Value Engineering Study

VE# 201106

US 150 from KY49 to Leslie Ballard Road

Item Numbers 4-8308 and 4-8309

IC-01

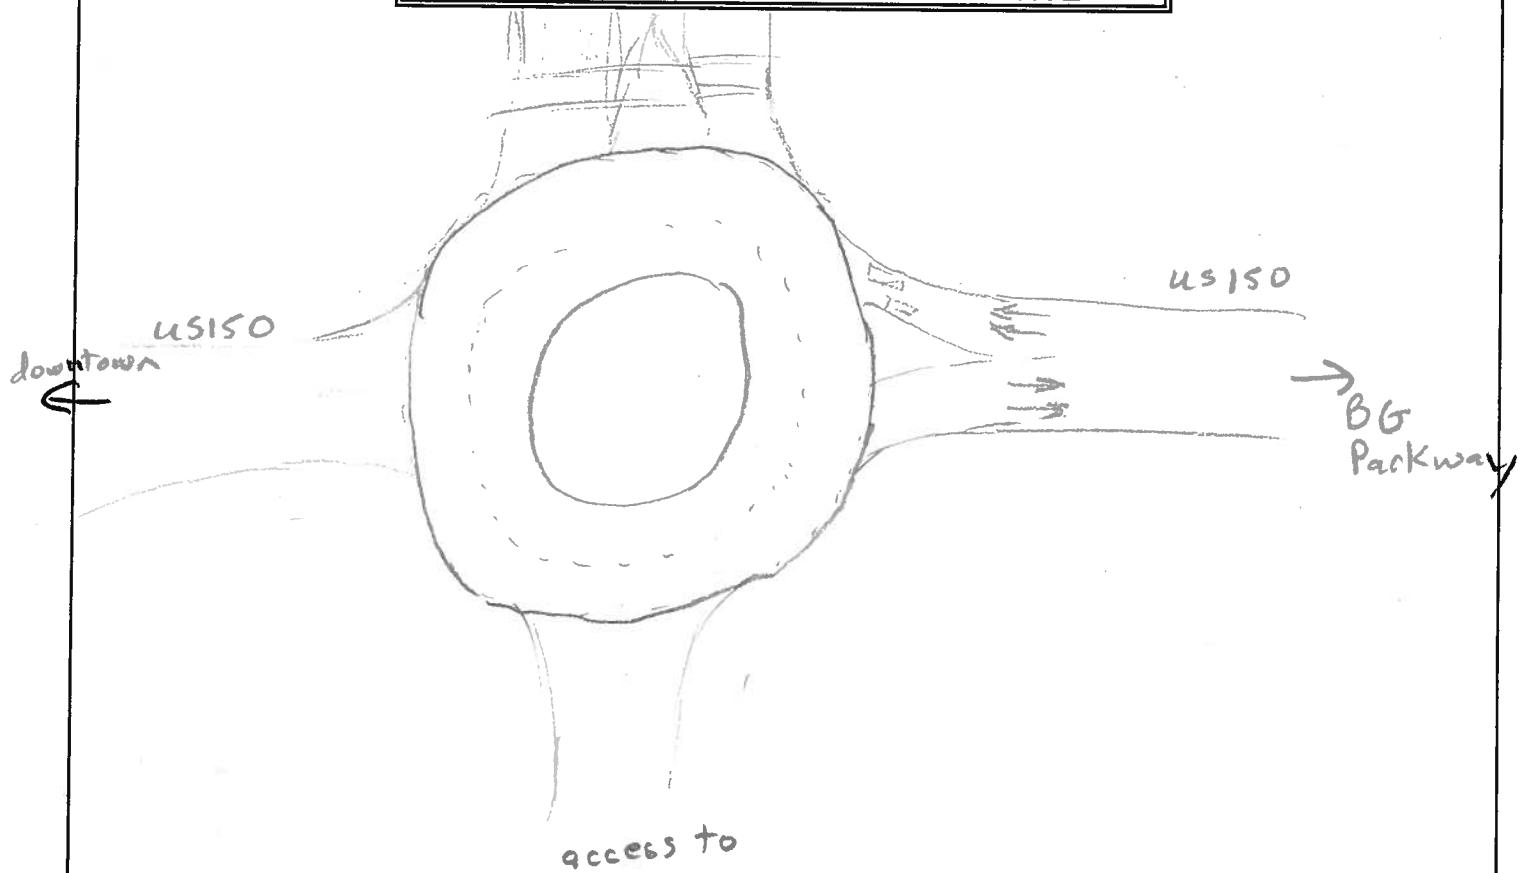
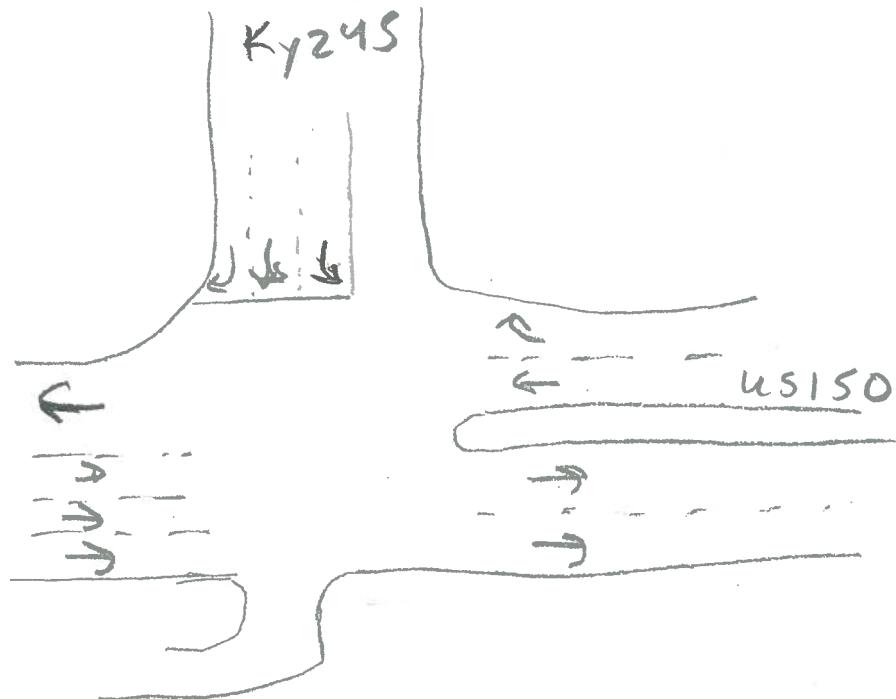
Propose to remove at grade intersection
at Ky 245/US150 and replace with a dual
roundabout.

The building of the roundabout would eliminate the construction of dual left off of Ky 245 which would decrease the R&W and the construction of Pavement on that approach. There would be the benefit of little delay for the off-peak hours.

The Signal would delay each approach but the roundabout would decrease delays and the speeds at the intersection. The roundabout also would decrease the wear on the pavement because of the stop/Go that is caused by the installation of traffic signal. There would be an increase in safety because of the elimination of rear ends and possible angle crashes. Eliminating the signal would improve the delay because of the installation of two other signal at the ramps. The installation of roundabout

IC-04

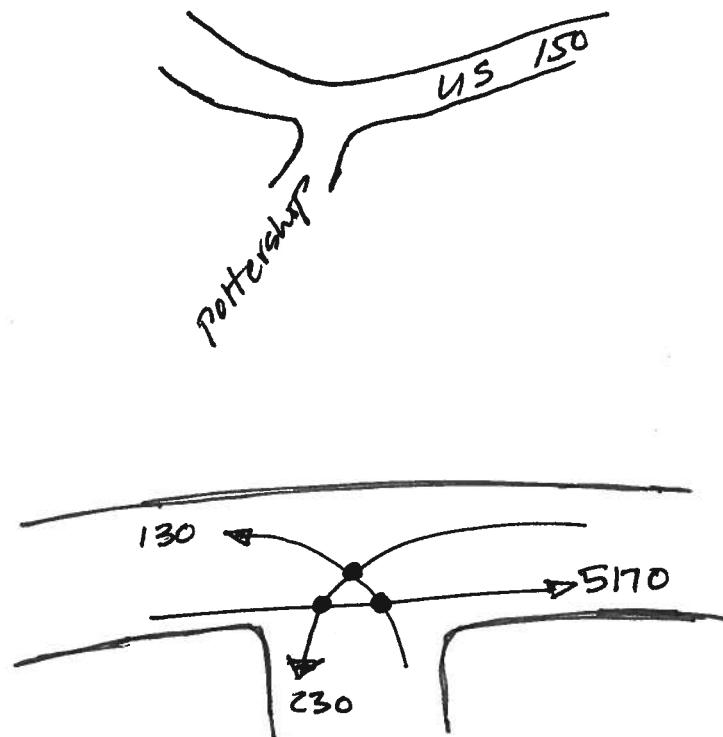
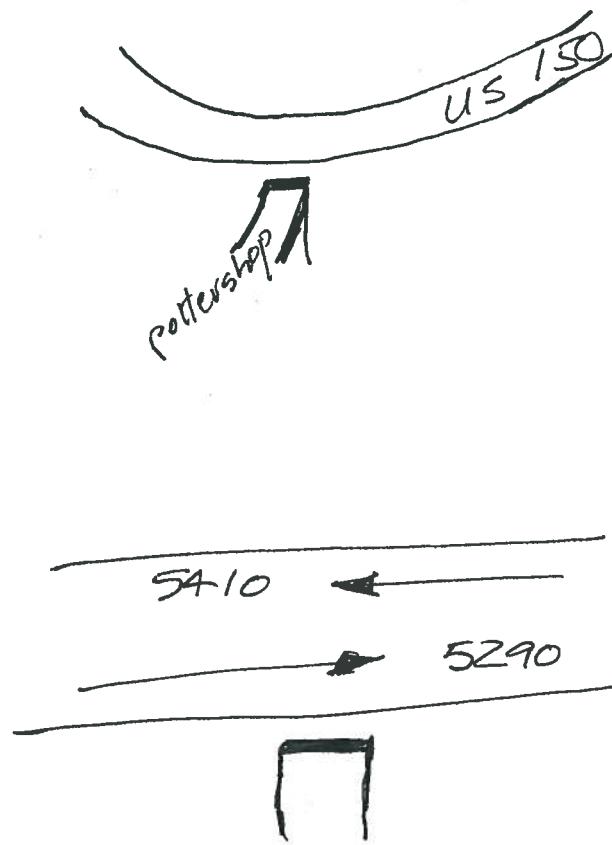
CLOSE ~~POTTERSOP~~ INTERSECTION OF POTTERSOP
LANE # US 150 AT STA 148+93 .

It is proposed to completely close Pottershop Loop to US 150 @ station 148+93. ~~This~~ This closure eliminates 3 conflict (crash) point, therefore eliminating possibility of accidents @ this location and maintain the traffic flow on US 150. The ~~number~~ ^{of users} inconvenienced by this closure would be around ^ 350 cars a day who would have to take a different route. This proposal enhances the value of realignment of west end of Pottershop Loop with Springhill Drive @ US 150.

IC-06

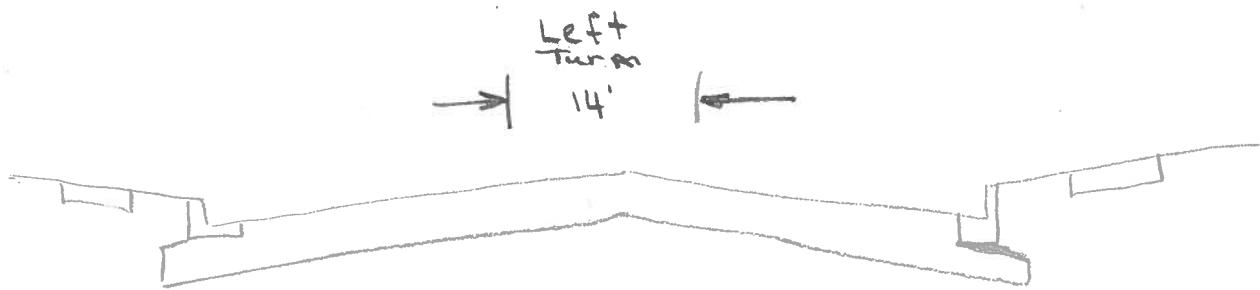
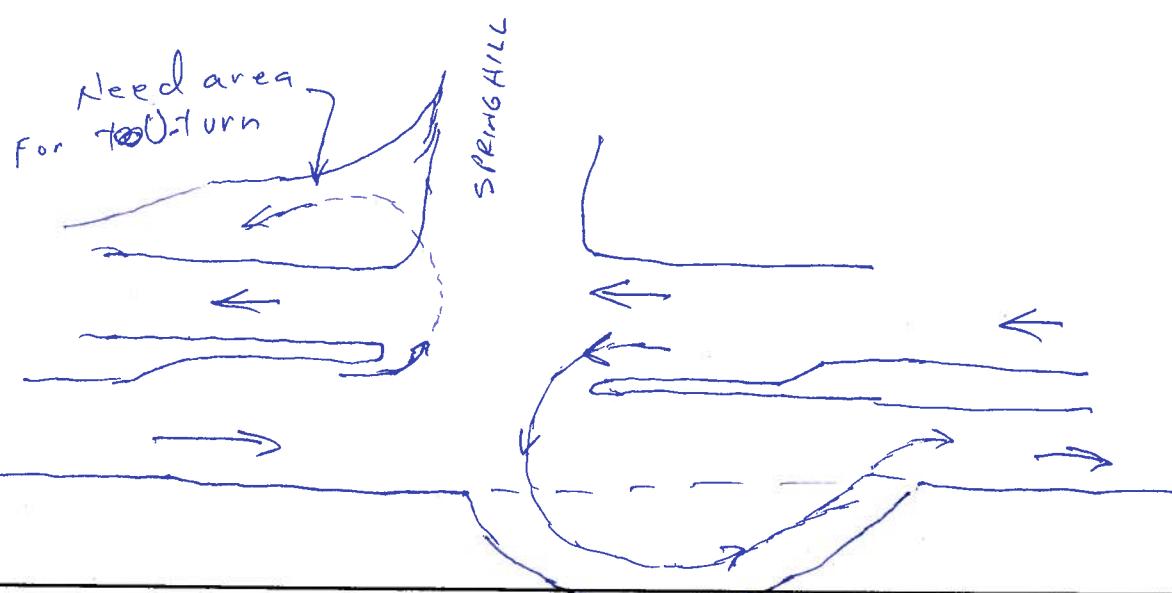
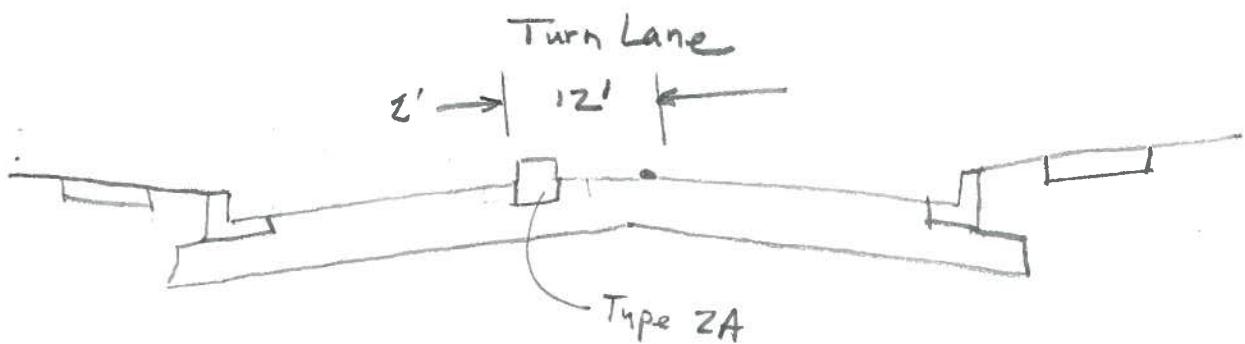
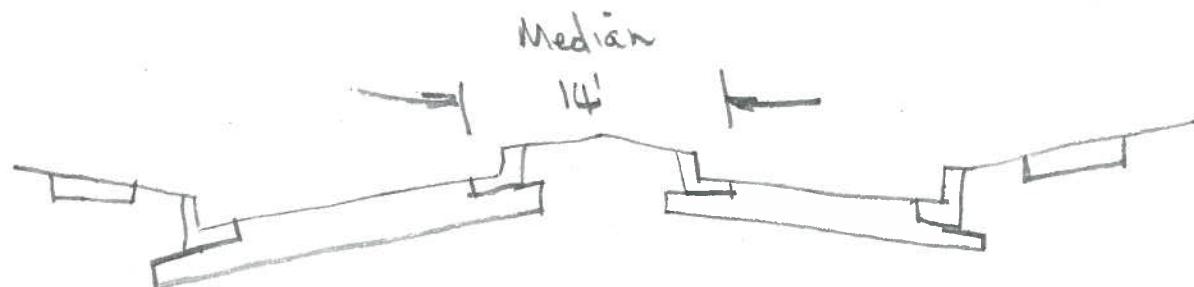
| K50 Raised median from sta 116+00 to sta 171+00 with left turn lanes at sta 130+00 (Springhill) and sta 148+00 (Pottershop) | |

The current design includes a continuous left turn lane. This configuration allows left turns at all intersections and residential entrances. There are currently 9 residential, 4 approach and 1 commercial access points from Sta 116+00 to Sta 171+00. This change would eliminate conflicting left turn movements by placing median u-turns at Sta 130+00, Spring Hill Dr. and Sta 145+00, Pottershop Rd (South). The median would be raised and prohibit left turns at other locations. This reduces the number of left turn conflict locations from 14 to 2. Reducing left turn conflicts will improve traffic flow thru this portion of the project. The raised median will provide an opportunity for improving aesthetics by allowing landscaping in the median.

Widen to allow larger turning radii

IC-11

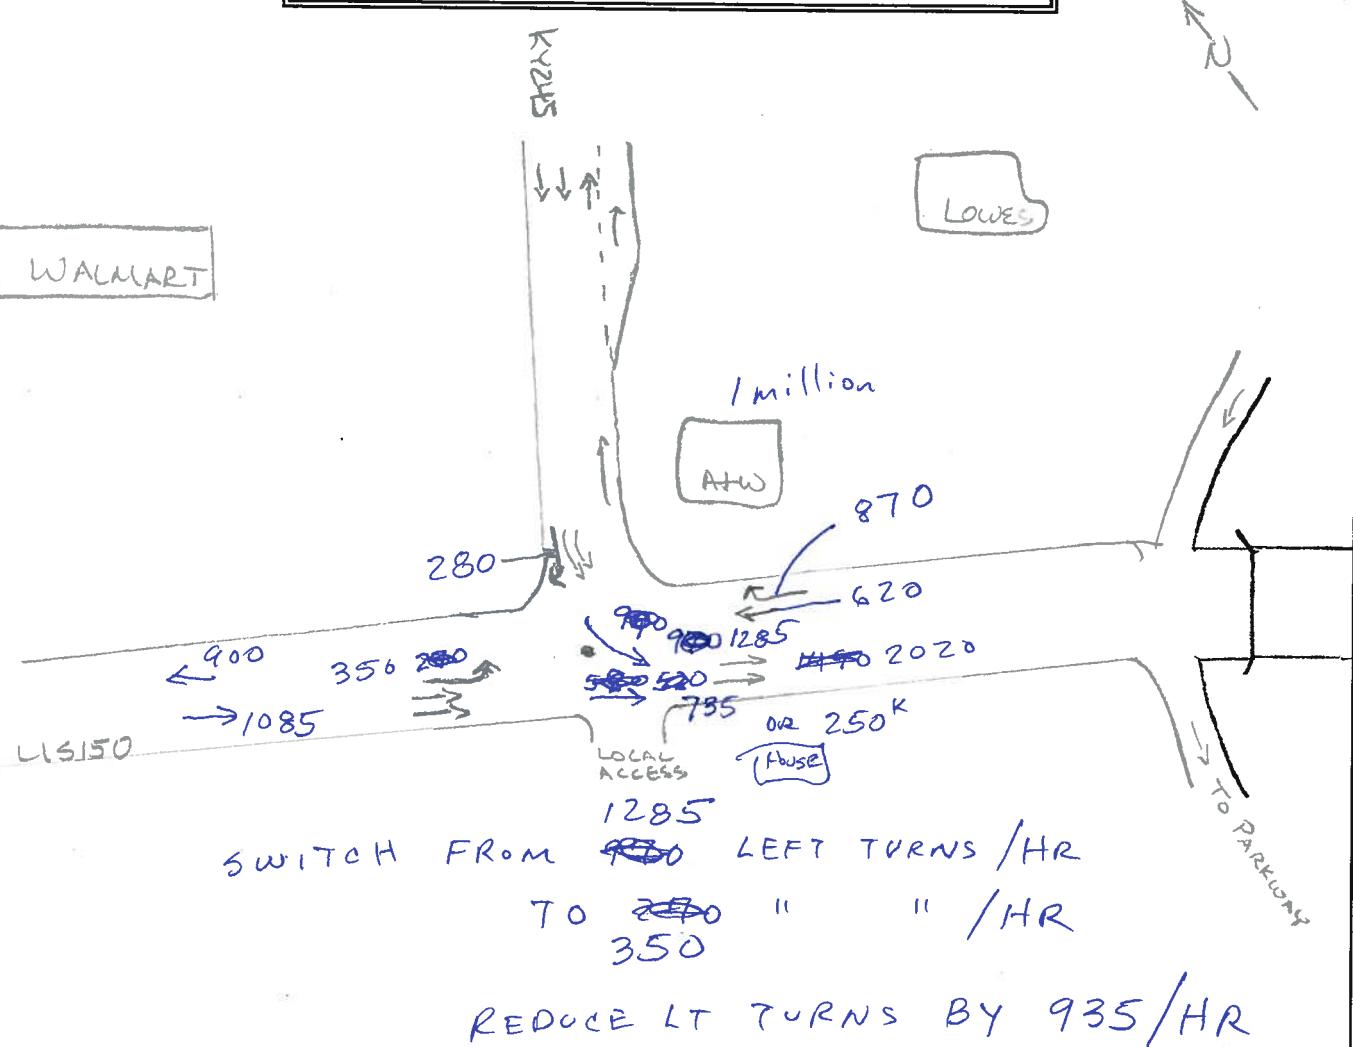
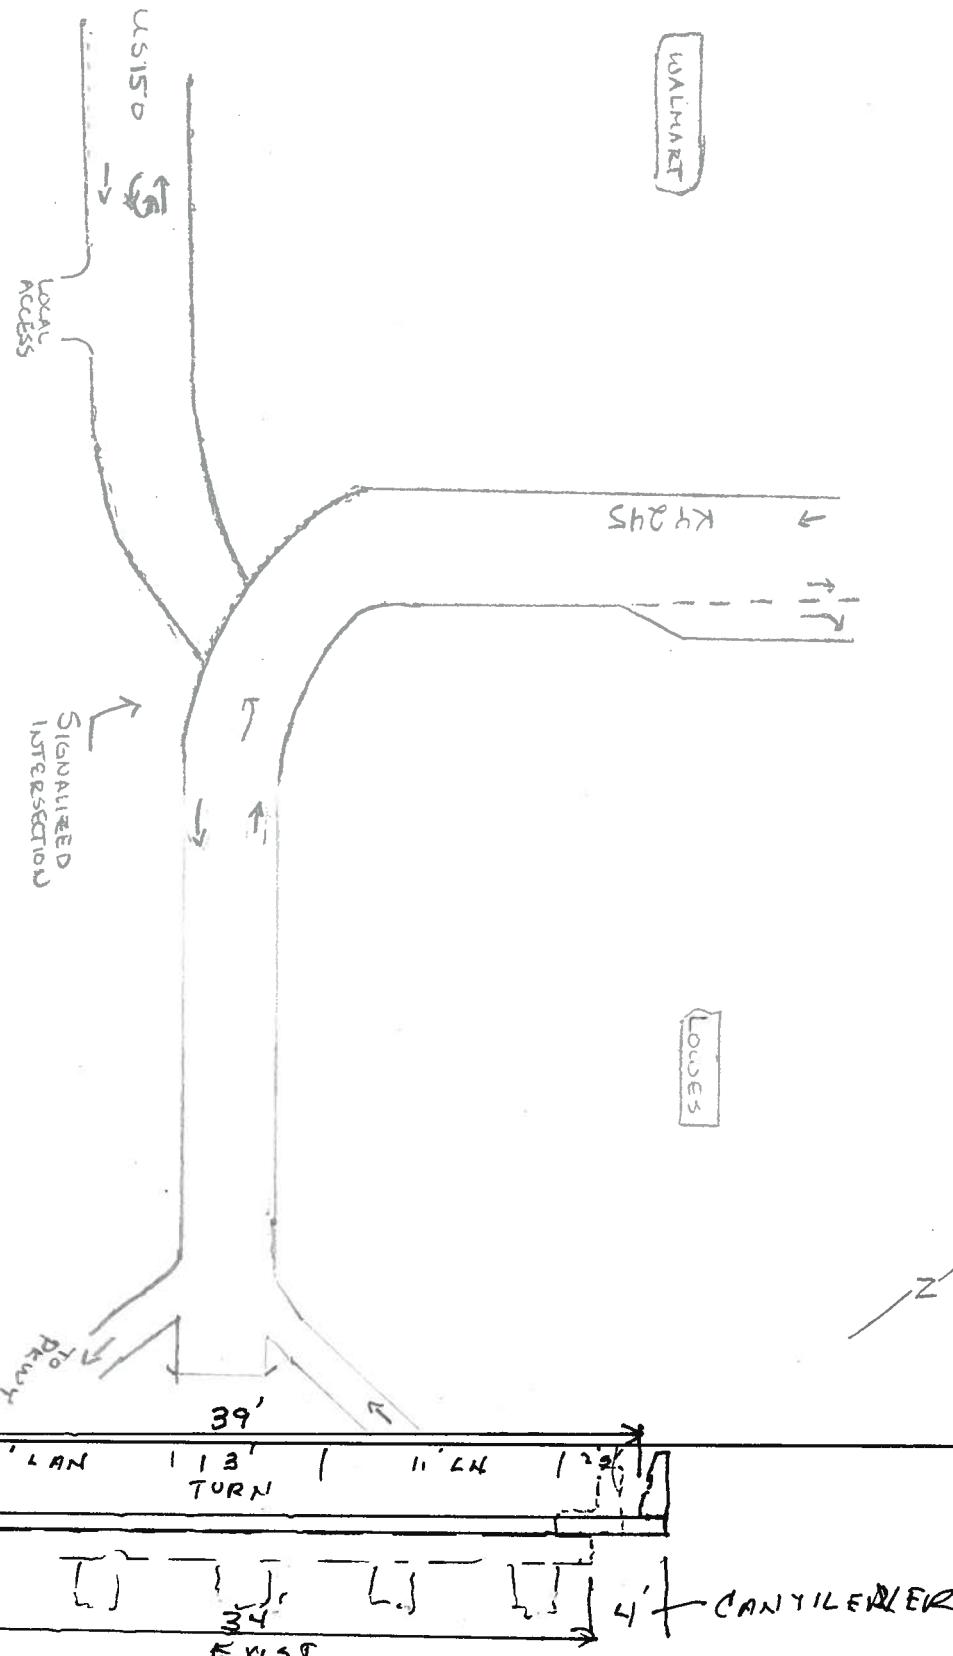
CONSTRUCT HORIZONTAL CURVE FOR US-150 AND KY 245 INSTEAD OF 90°
T-INTERSECTION, ALLOWING MAIN FLOW OF TRAFFIC TO CONTINUE ON KY 245
ONTO US 150. EASTBOUND US 150 WILL APPROACH KY 245 AT CURVED
INTERSECTION,

EXISTING TRAFFIC REPORTS INDICATE THE MAJORITY OF TRAFFIC IS PRESENT ALONG KY 245, NOT US 150. INSTALLING A HORIZONTAL CURVE AT KY245 / US-150 INTERSECTION MAY INCREASE CAPACITY AND MAINTAIN MOBILITY BY IMPROVING THE LEVEL OF SERVICE FOR KY 245 AND WESTBOUND US 150 AT INTERSECTION. EASTBOUND US 150 WOULD APPROACH KY 245 AT A T-INTERSECTION. THIS ALIGNMENT MAY REQUIRE THE TAKING OF A SMALL BUSINESS ON THE NORTHEAST CORNER OF INTERSECTION, HOWEVER, THIS BUSINESS OWNS A LARGE PARCEL ADJACENT TO THE EXISTING LOCATION WHICH WOULD ALLOW FOR QUICK CONSTRUCTION AT MINIMAL RELOCATION COSTS. THIS ALIGNMENT MAY REMOVE THE NEED FOR A FUTURE 3RD LEFT TURN LANE TURNING EASTBOUND ONTO US150 FROM KY245. THIS FUTURE LEFT TURN LANE WAS ELIMINATED WITH THE PRACTICAL SOLUTIONS ALTERNATE, SO POSSIBILITY OF THE REMOVAL OF LANE FROM WARRANT WILL STAY WITHIN THE SCOPE. BY MAINTAINING MOBILITY WITH REDUCING CONGESTION, THIS MAY ALLOW FOR THE REDUCTION OF A LARGE SCOPE OF THIS PROJECT WEST OF THE INTERSECTION ALONG US 150. CURRENT R/W ILLUSTRATES THAT KYTC OWNS ENOUGH R/W SOUTH OF EXISTING ALIGNMENT TO ALLOW FOR CONSTRUCTION OF APPROACH WORK AND SLIGHT US150 REALIGNMENT. THIS WILL COORDINATE WITH THE PROPOSED LANE REDUCTIONS DUE TO INCREASED CAPACITY.

DRIVING FORCE FOR
NEEDING 2 LANES (ACTUALLY 3)
TURN

THUS NEEDING TO CARRY THEM ACROSS
BRIDGE
